07Sept04 SDD21 Comparisons

Proposed Ad-Hoc Channel Description - as of July04

SDD21 Proposals

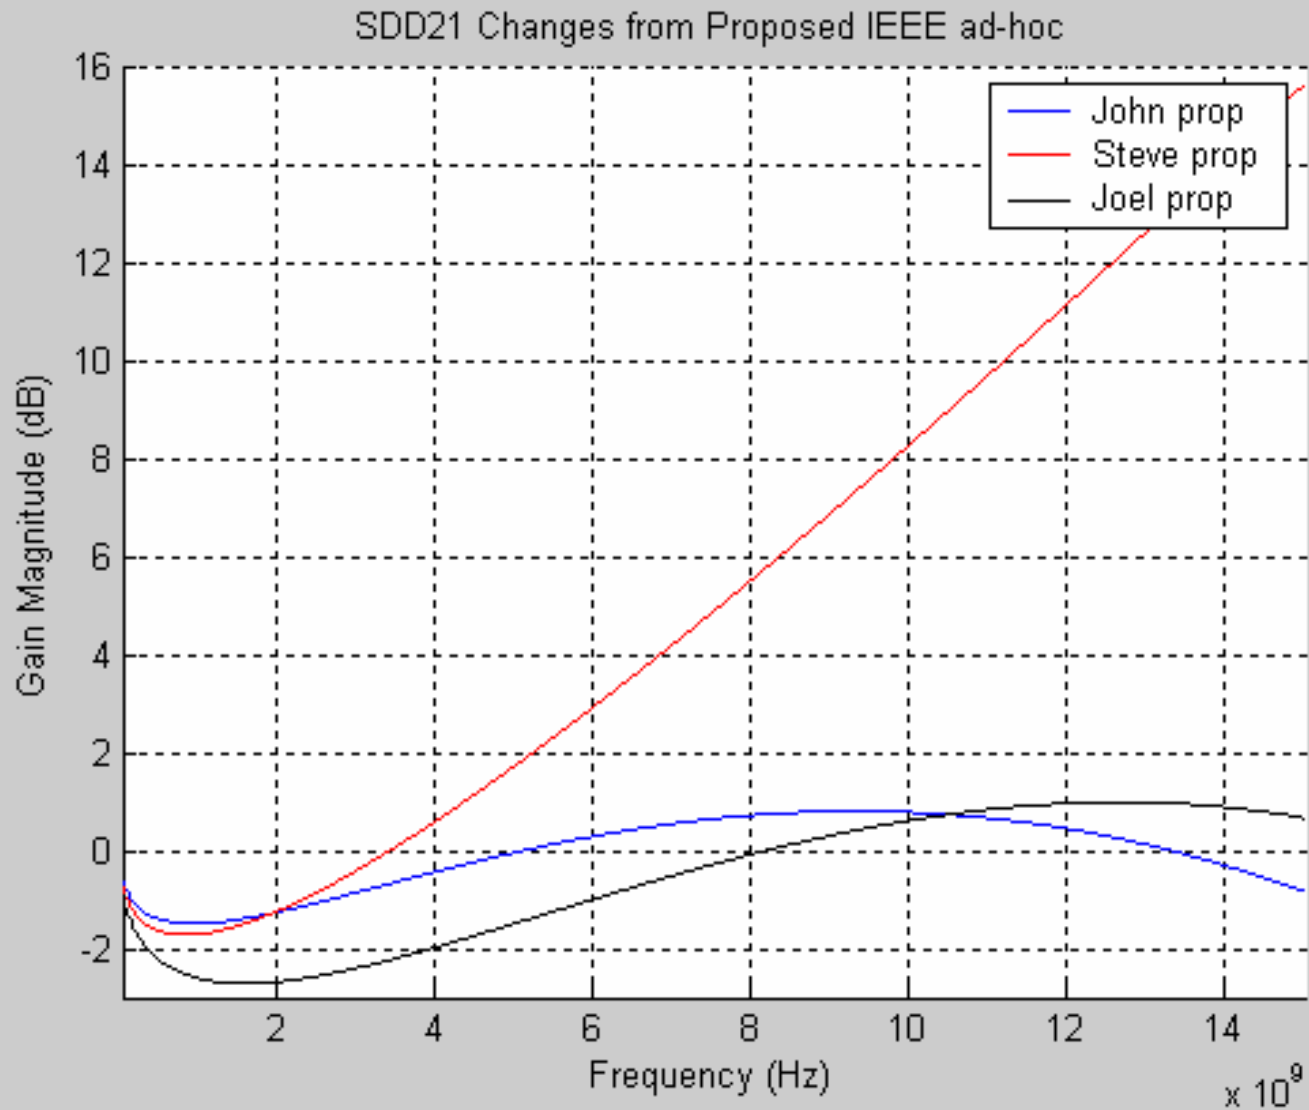
- Joel's proposal falls within the straw poll criteria.
- We need 3dB more in the lower frequencies per the July04 meeting. John's proposal doesn't provide enough relief at the lower frequencies and has thus been withdrawn.

- From Joel's proposal, 6Ghz and higher, the change is within +/- 1dB. If this is enough to cause major panic to a particular signaling concept, one should question if that signaling concept is a good idea to begin with.

- Steve's proposal suggests a 15dB gain at 15Ghz and a 3dB gain at 6Ghz. This will effect the adopted Dk/Df values from July04. The overall material cost will increase because we eliminate the use of lower end improved fr-4 material groups, in particular for the 2 connector 40inch case and the 3 connector 33inch case. Much work will be required here.

- We have been okay with the July04 SDD21 equation with minor changes. What happened that people are changing their positions so dramatically now?
- Research presented shows Steve's proposal is too restrictive for many channel cases.

- We will throw out a lot of data, as well as many channels by adopting Steve's proposal.
